Japan Comments for Battery Durability GTR EVE43

3. February.2021

4-3 SOH cumulative frequency at 5 and 8 years

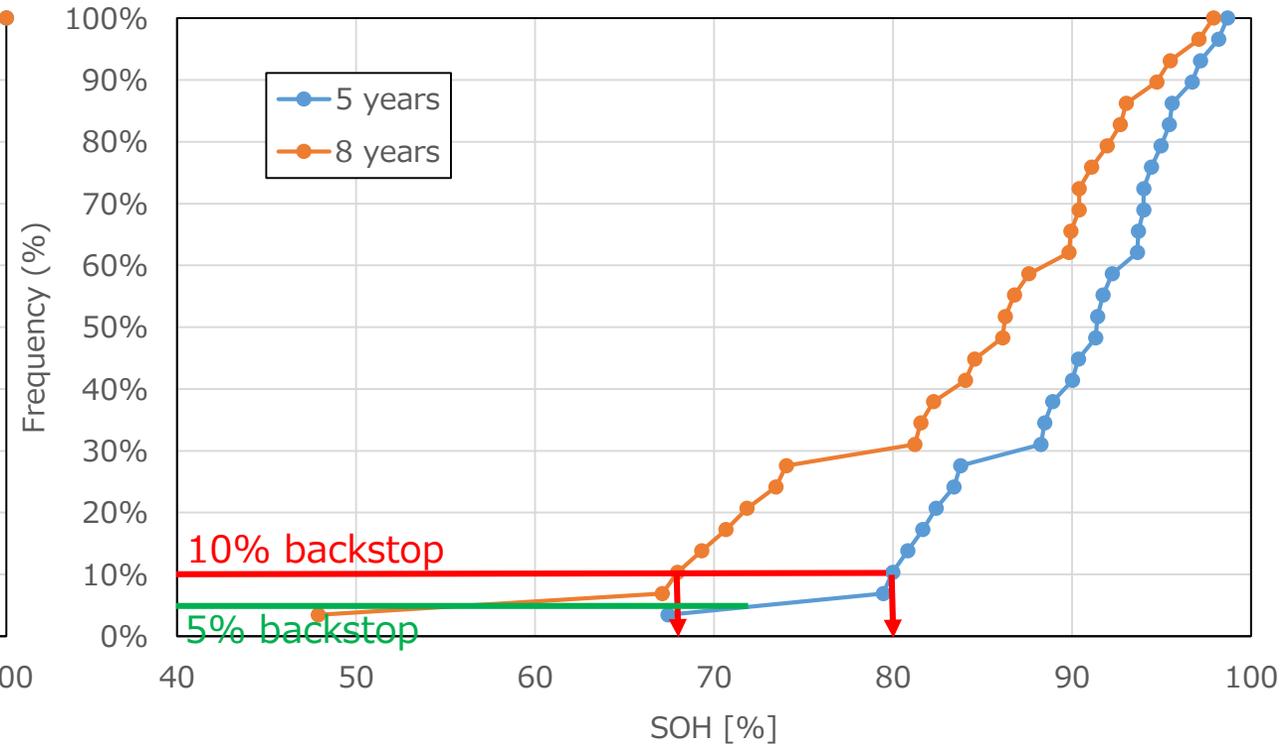
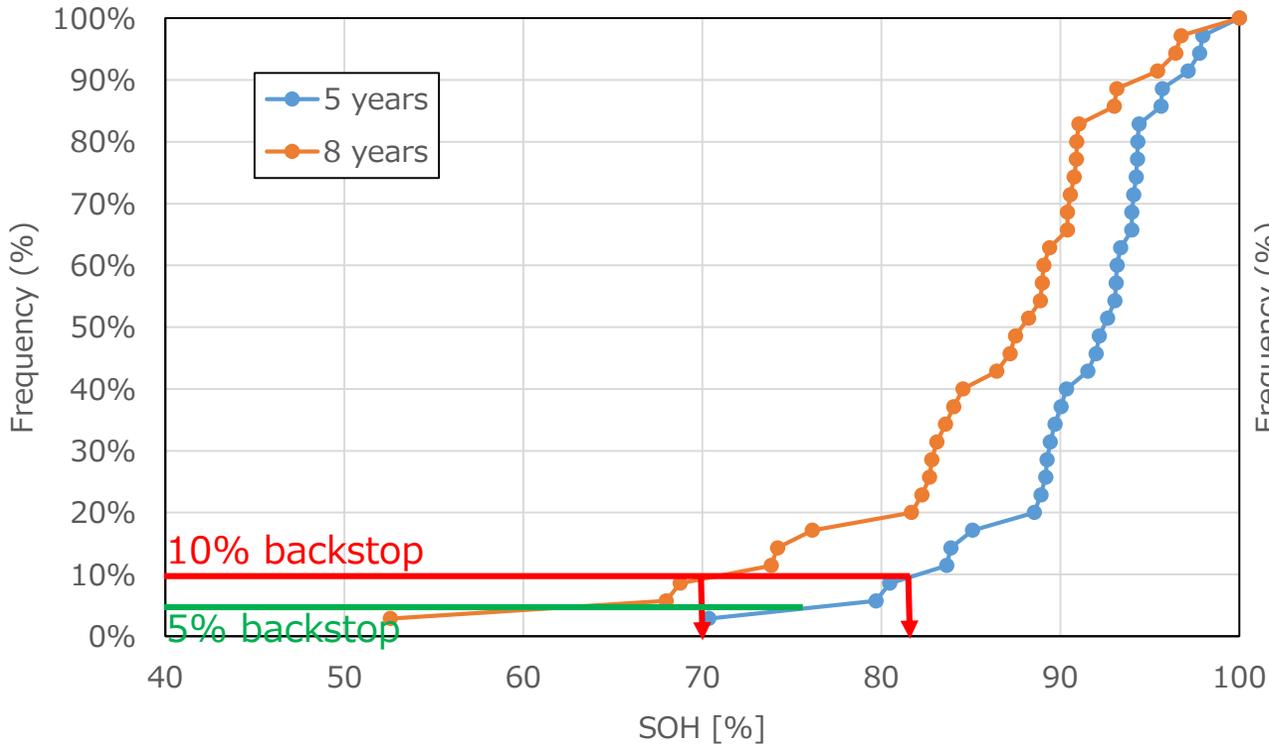
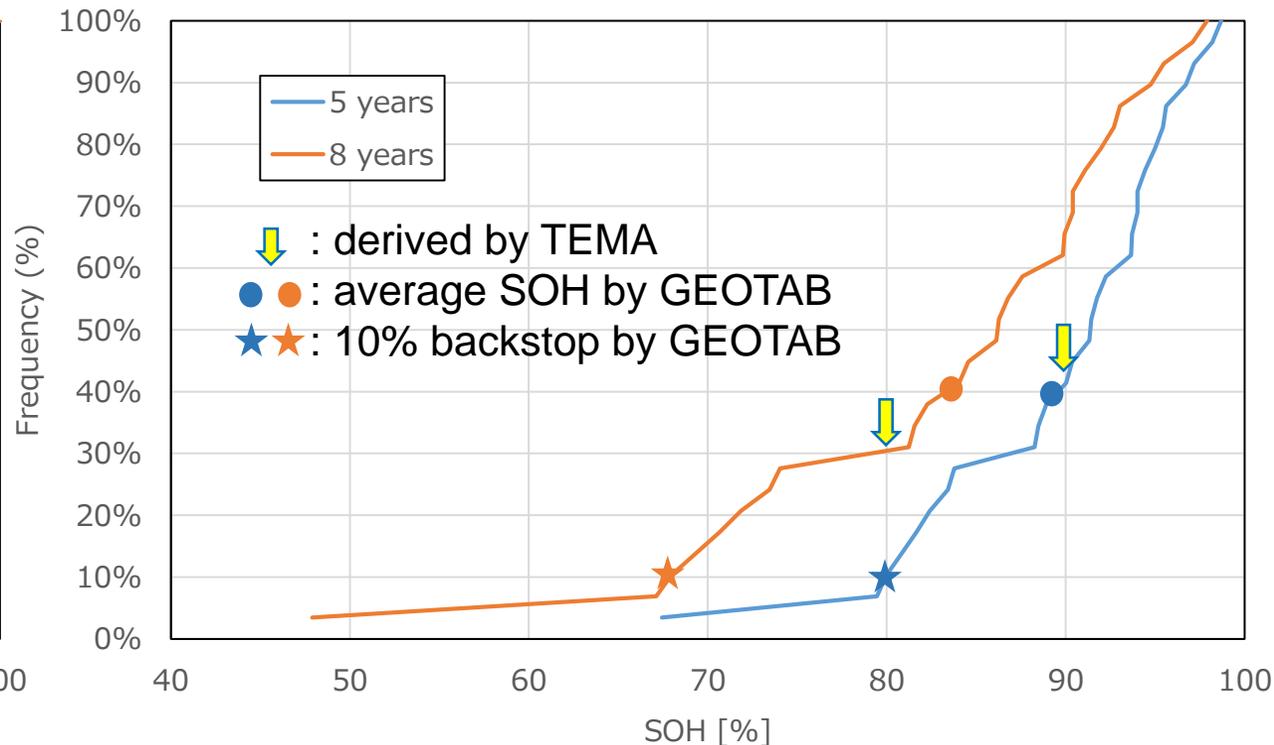
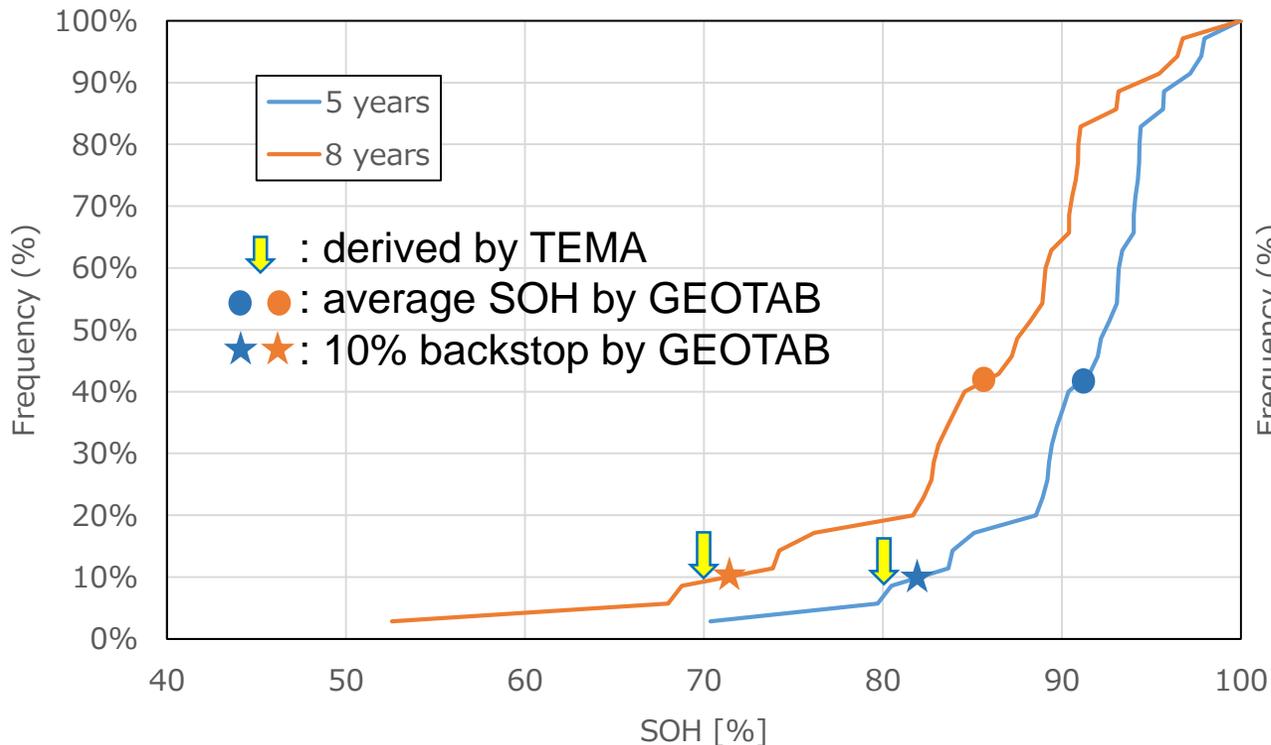
- ✓ MPRs based 5% backstop may lead false pass/fail decision → **propose 10% backstop**
- ✓ MPRs based 10% backstop are going to be approximately

80%@5yrs / 70%@8yrs for both PEV and PHEV

4-4 Comparison between TEMA model and GEOTAB data

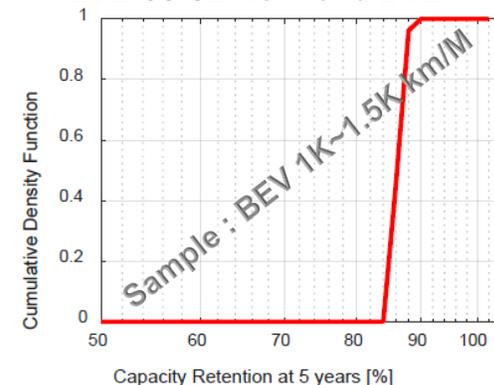
PEV				PHEV			
	5yrs		8yrs		5yrs		8yrs	
	TEMA	GEOTAB	TEMA	GEOTAB	TEMA	GEOTAB	TEMA	GEOTAB
Fleet	80%	91%	70%	86%	90%	90%	80%	83%
Backstop*	80%	82%	70%	71%	90%	80%	80%	68%

* : 5% in case of TEMA, 10% in case of GEOTAB
